MEMO

Explanation of the requested additional information for IQE permit application

To address the requested information, the original noise impact assessment report (NIA) has been updated. This document provides brief explanation and reference to the NIA.

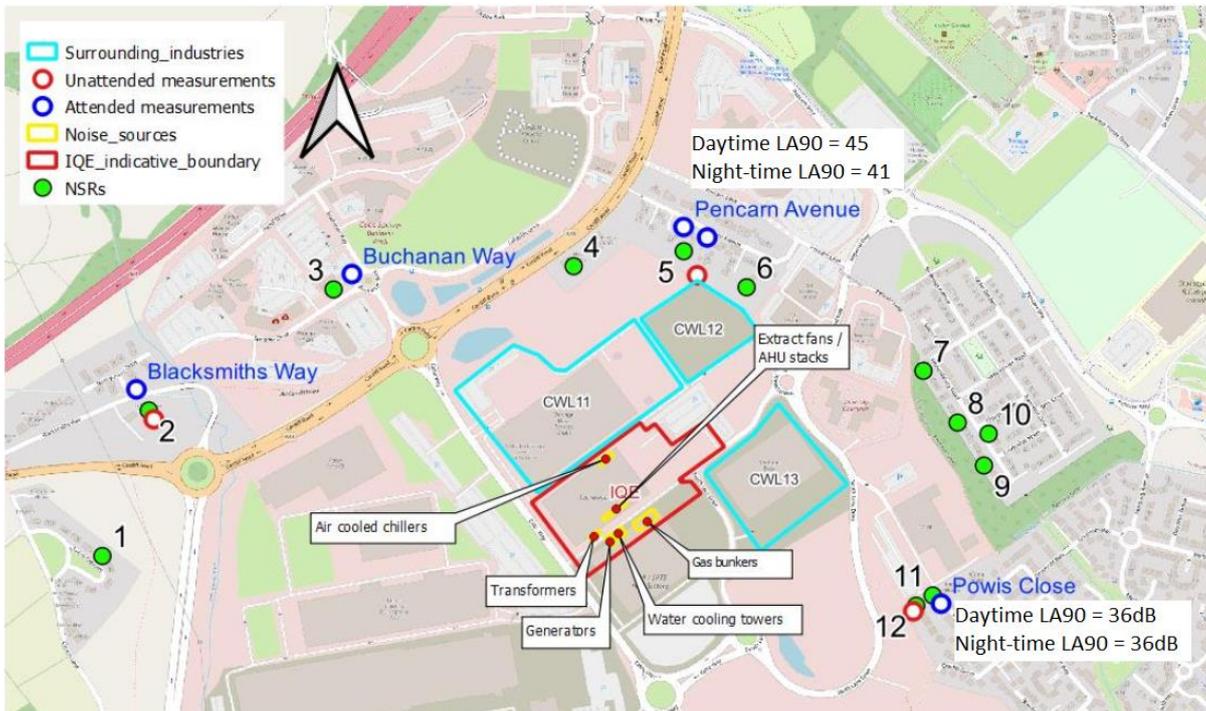
Following the review of the response to the not duly made letter previous response for how the background at Edmondsbury Road were derived (received 22/07/2024), provide calculation steps for the stated interpolation.

Figure 3-1 in the report shows the locations of the noise sensitive receptors in green. This has been copied below, with labels added to show the measured daytime and night-time LA90 noise levels for Pencarn Avenue and Powis Close. Background noise levels are lower at Powis Close than at Pencarn Avenue principally because Powis Close is further from the main noise sources in the area, the M4 and the A48. Traffic on both of these roads is reasonably constant, and is considered likely to play an important role in determining the background LA90 noise levels.

At Edmondsbury Road background noise levels are considered likely to be lower than the 45dB measured at Pencarn Avenue and higher than the 36dB measured at Powis Close. The halfway point between 45 and 36 is 40.5, and this has been rounded down to 40dB to give more weight to the lower levels measured at Powis Close.

At Edmondsbury Road background noise levels are considered likely to be lower than the 41dB measured at Pencarn Avenue and higher than the 36dB measured at Powis Close. The halfway point between 41 and 36 is 38.5, and this has been rounded down to 38dB to give more weight to the lower levels measured at Powis Close.
